PART NAME		FAIR NAME	
ETM TEL ASSY, FULL COMPLETE, BSC6		ETM TEL ASSY, FULL COMPLETE, BSC6	
REGION	E CAN02	DATE	12.23.2011
DRAWER	E CAN02	TIME	2:40:33
CHECKER	A. BOGGS	SCALE	D
APPROVAL	A. BOGGS	SCALE 1:1.2	PROJECTION
NEXT ASSY		D0900512	
MATERIAL		N/A	
FINISH		N/A	
JUNCH		N/A	
DIMENSIONS ARE IN INCHES (MM)		DIMENSIONS ARE IN INCHES (MM)	
TOLERANCES:		TOLERANCES:	
XXX		XXX	
XXX		XXX	
ANGULARITY		ANGULARITY	
SECTION A-A		SECTION A-A	
SCALE 1:6		SCALE 1:6

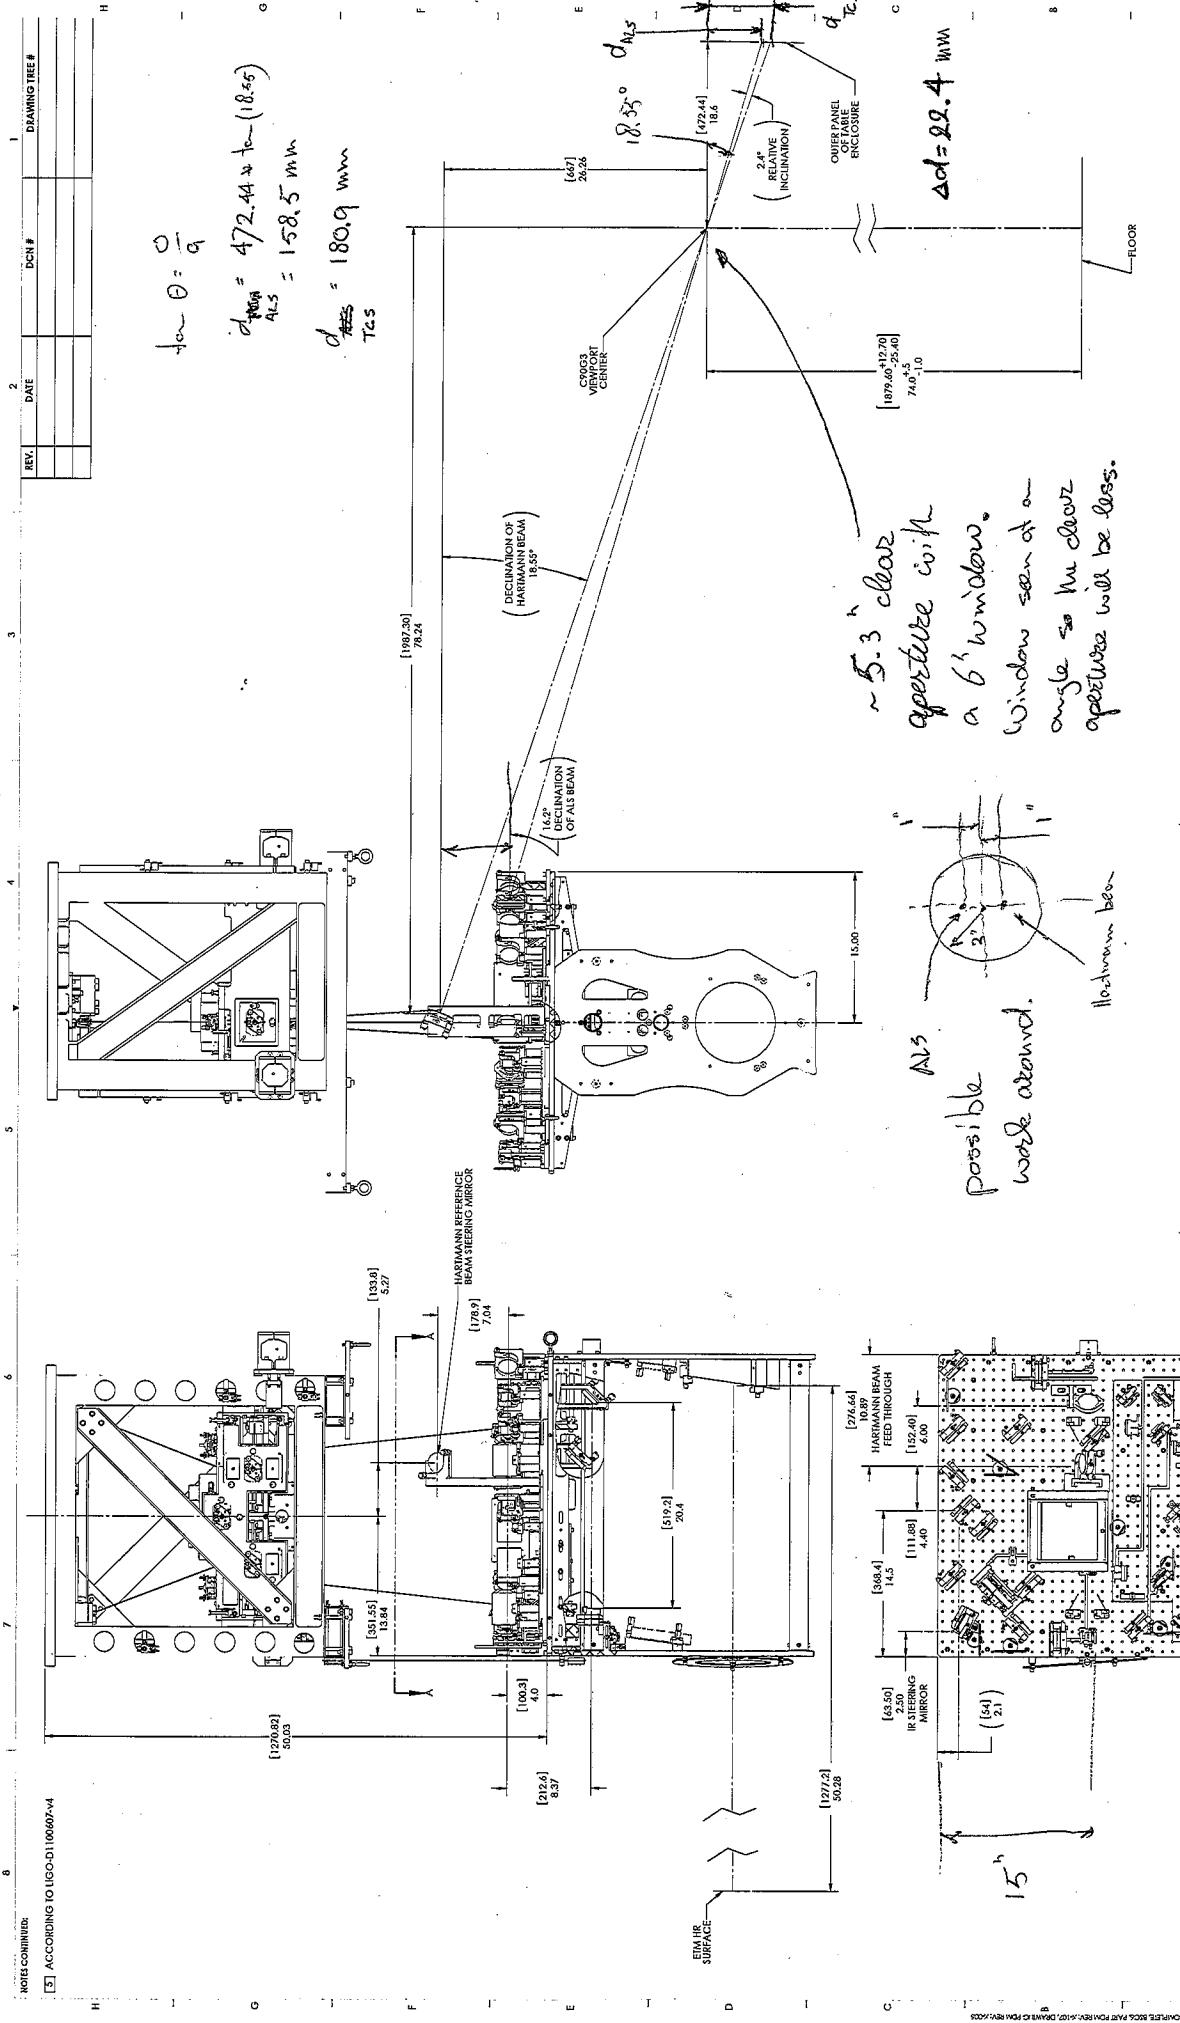
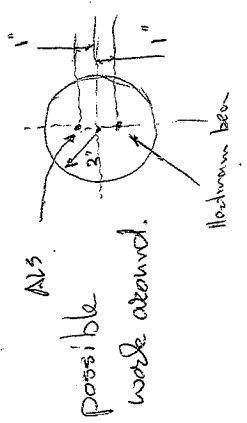
160 vs 180
BSC6

$\tan \theta = \frac{0}{9}$
 $d_{HBM} = 472.44 \times \tan(18.35)$
 $d_{ALS} = 158.5 \text{ mm}$
 $d_{AZS} = 180.9 \text{ mm}$
 TCS

$\Delta d = 22.4 \text{ mm}$
 ~5.3" clear aperture with a 6" window. Window seen at an angle so the clear aperture will be less.

14.50
 4.40
 10.80
 30.00"

DETAIL B
SCALE 1:18

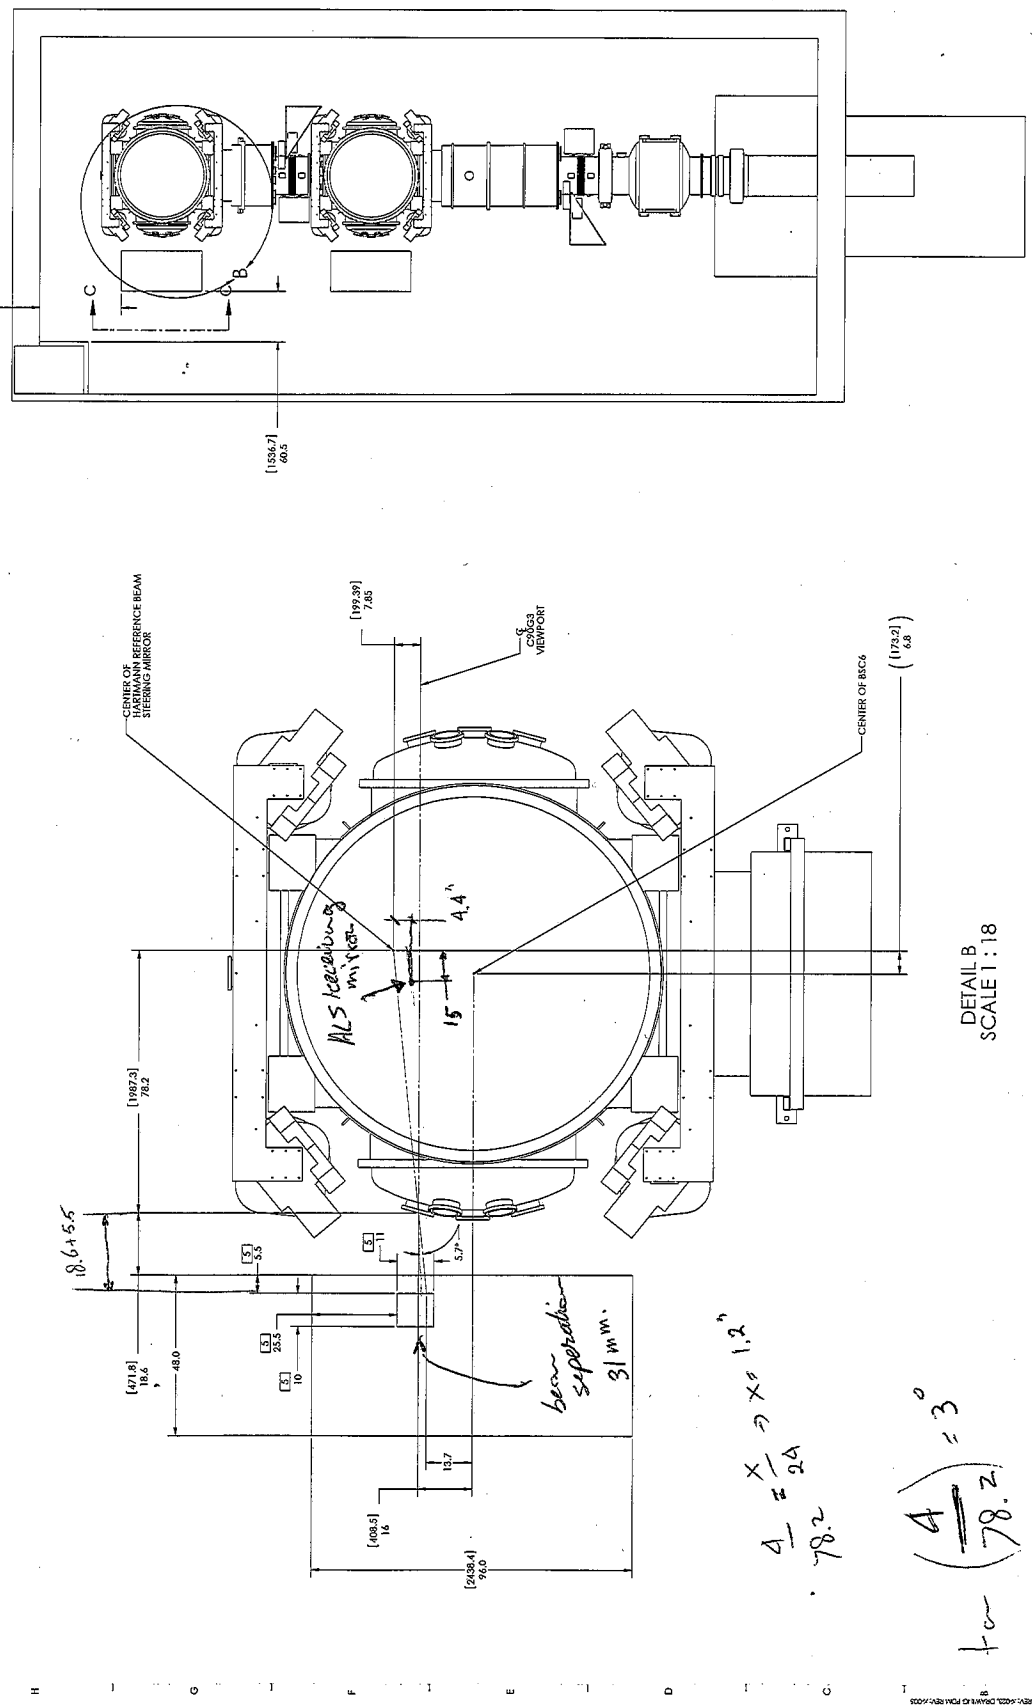
$$\frac{18.6}{8.5} = 2.11$$

$$\frac{4}{78.2} = \frac{x}{24} \rightarrow x = 1.2$$

$$\tan\left(\frac{4}{78.2}\right) = 3^\circ$$

SCALE 1:72

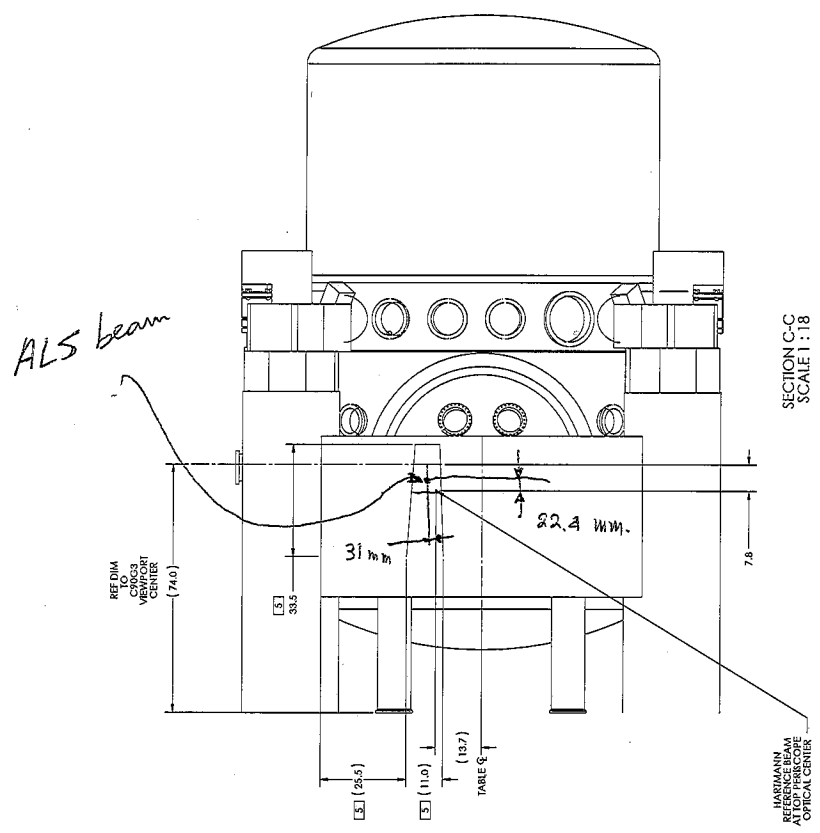
ALS injection beam is 22.4 mm above
 and 31 mm further away (w.r.t. LUFA) than
 the AR reflected TCs beam.
 Assumed ~~the~~ both beam are going through the
 center of the viewport.
